PROJECT: **JACKSON COUNTY
SOLID WASTE MANAGEMENT FACILITY TRANSFER STATION**

DATE: **July 8, 2009**

RFP 9182-01 ADDENDUM No. 5

DOUBLE CHECK VALVE ASSEMBLY
VAULT INSTALLATION
OS&Y GATES

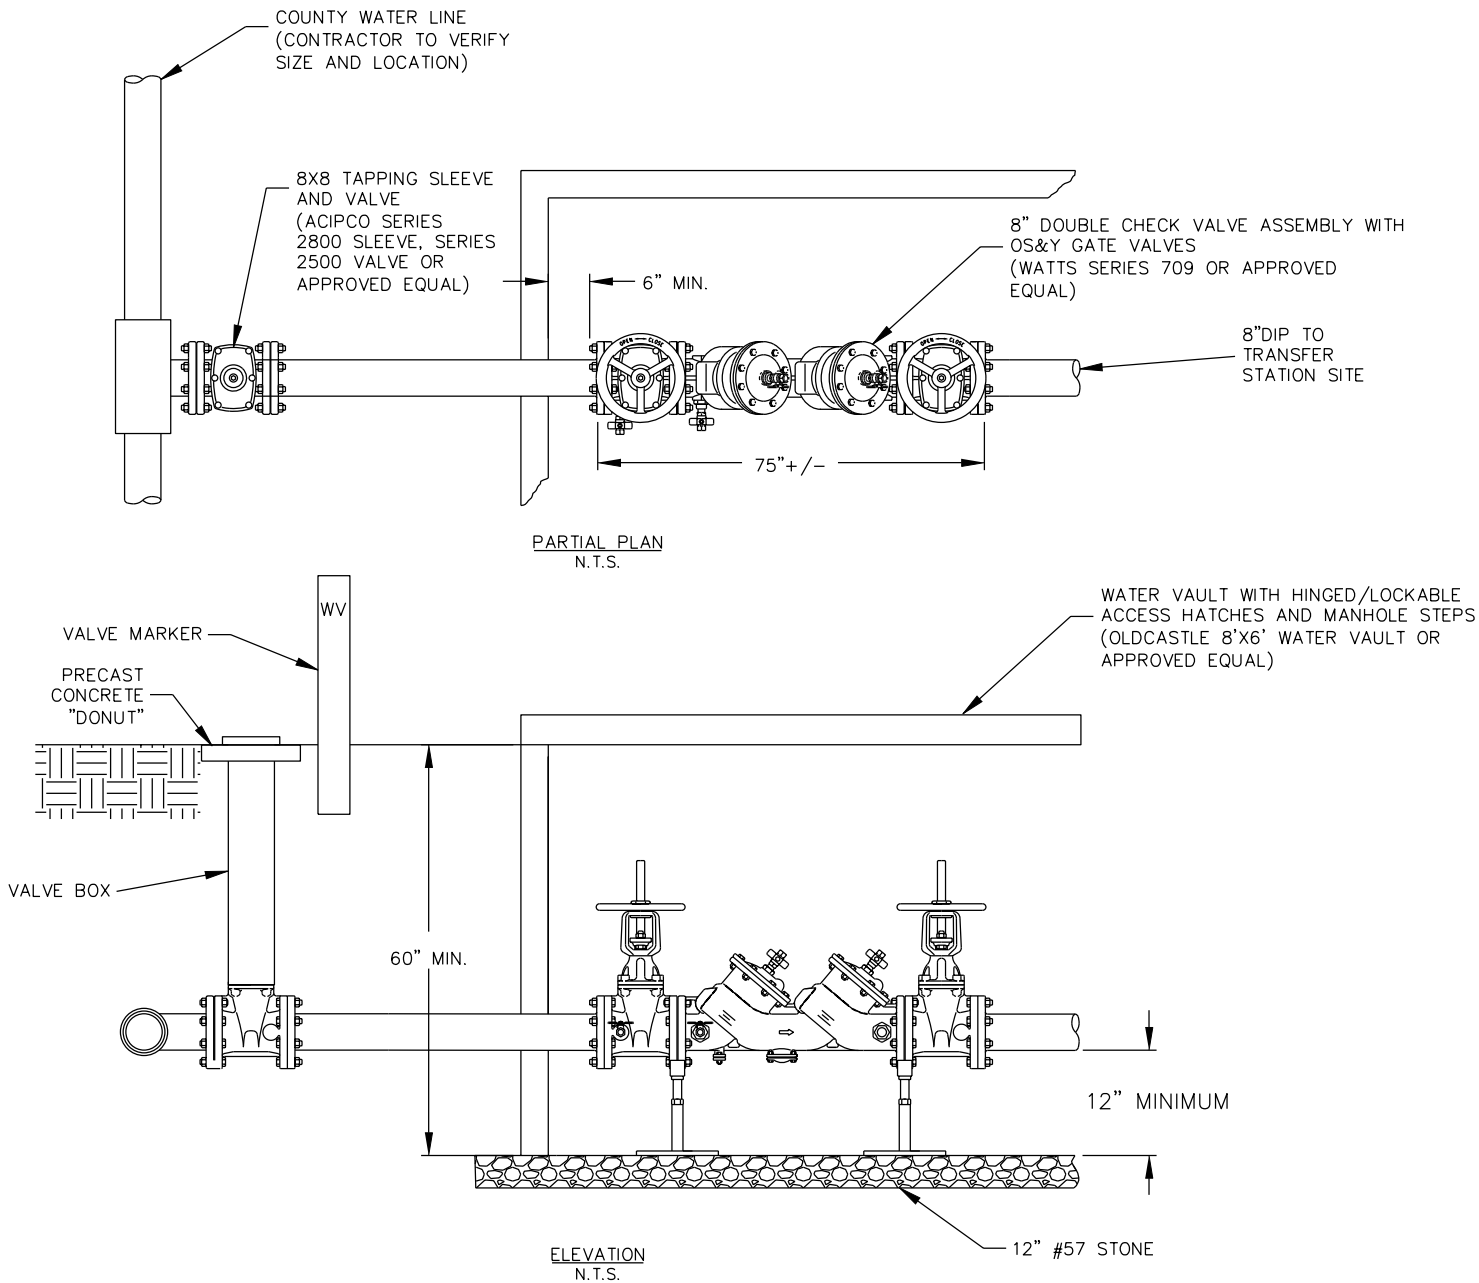
- h. Modify "DOUBLE DETECTOR CHECK VALVE IN CONCRETE VAULT" to read "DOUBLE CHECK VALVE ASSEMBLY IN CONCRETE VAULT". **Double check valve assembly vault installation detail is attached.**
